The Corporation of the District of Saanich

## Report

**To:** Mayor and Council  
**From:** Sharon Hvozdzanski, Director of Planning  
**Date:** August 3, 2018  
**Subject:** Subdivision, Rezoning, and Development Variance Permit Application  
File: SUB00607; REZ00446; DVP00404 • 3989 Holland Avenue

**Figure 2: 2009 Development Proposal - Three new RS-8 zone lots (Rejected)**

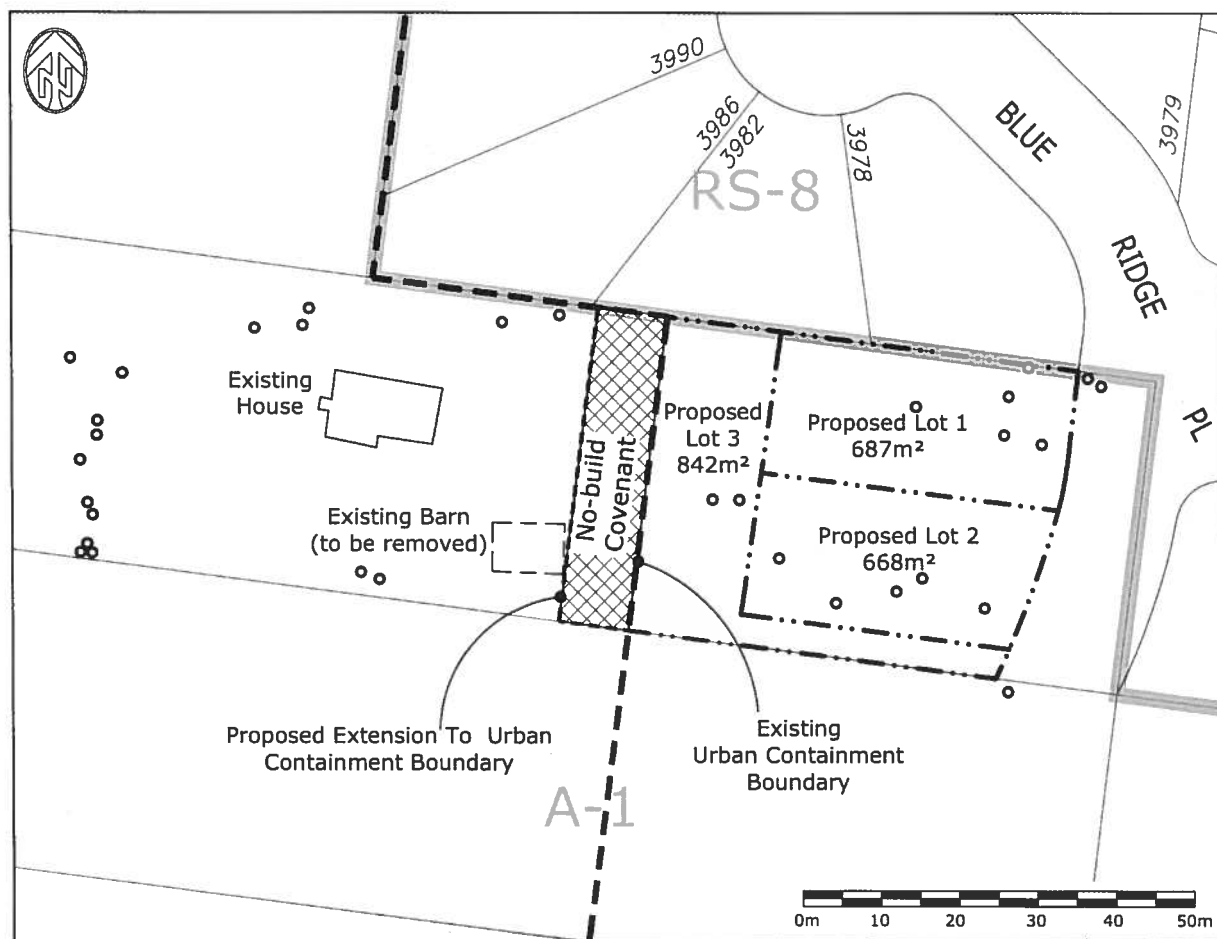
In late 2008 a rezoning and subdivision application for the subject property was submitted to Saanich. The proposal was to create three new RS-8 zoned lots (four lots in total). The layout of the proposed subdivision is illustrated in Figure 2. The development proposal also required an amendment to the Sewer Service Boundary and Urban Containment Boundary.

The application was formally considered by Council in June 2009, and was rejected.

Reasons for the lack of support for the application from Council and the community included issues such as: the loss of significant sized trees; the proposed expansion of the Urban Containment Boundary; loss of the urban tree canopy; loss of habitat and the impact on wildlife; increased traffic and related safety concerns; increased on-street parking; concern over the impacts from potential blasting during preparation of the site; urban – rural land use conflict; the potential for similar development of the adjacent two parcels to the south; and the lot sizes are too small and do not comply with the Local Area Plan policy.

**Figure 3: 2011 Development Proposal - Two new RS-8 zoned lots (Put on hold by applicant)**

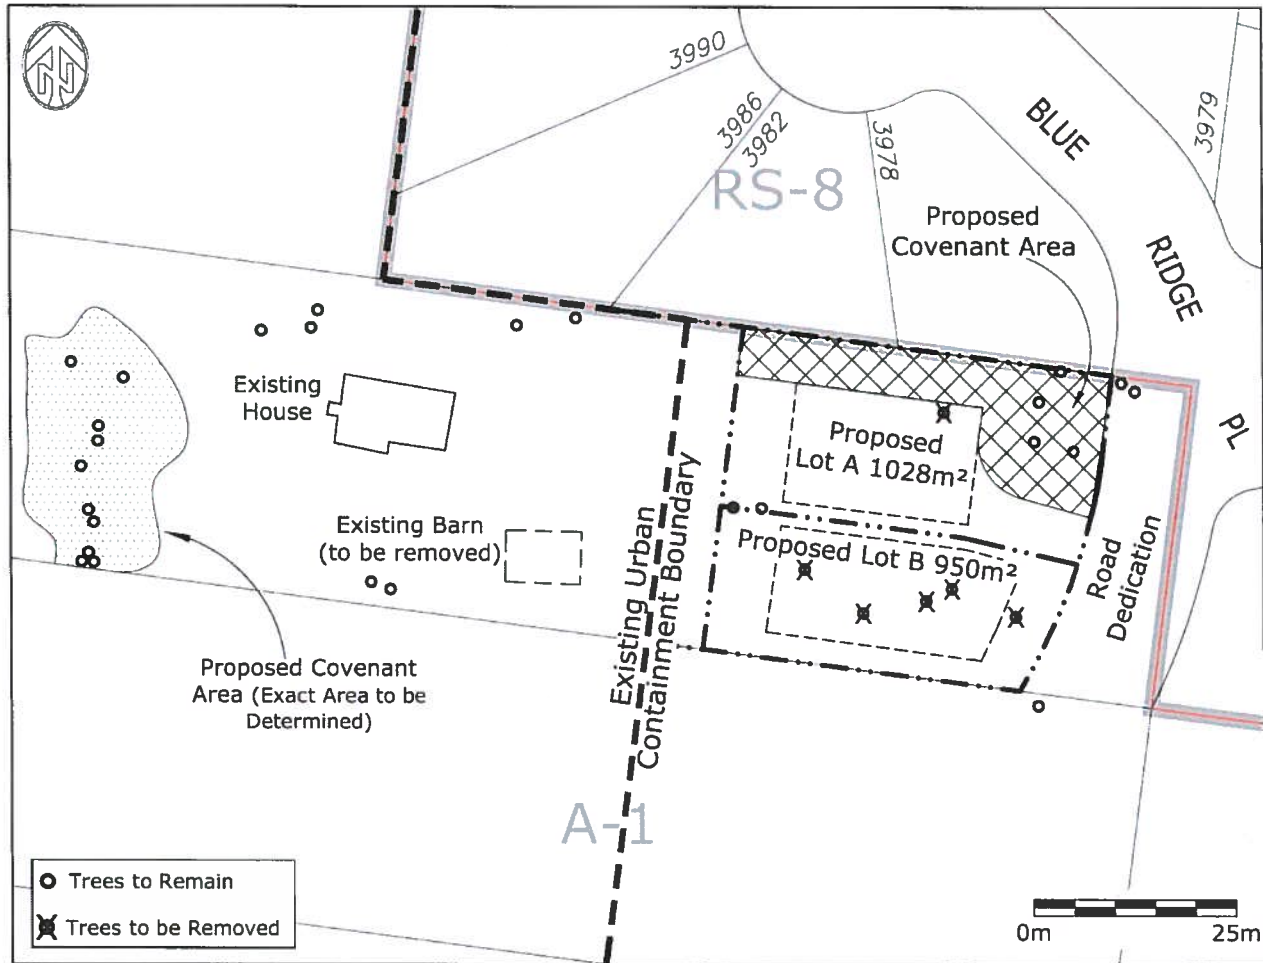
In late 2011, a Council report for the rezoning and subdivision application to create two new RS-8 (Single Family) zoned lots was prepared. The layout of the proposed subdivision is illustrated in Figure 3. The 2011 development proposal was adjusted so that unlike the 2009 proposal, amendments to the Sewer Service Boundary and Urban Containment Boundary were no longer required. Neighbourhood support for the proposal remained an issue. The applicant chose not to proceed to Council and asked that the application be put on hold.
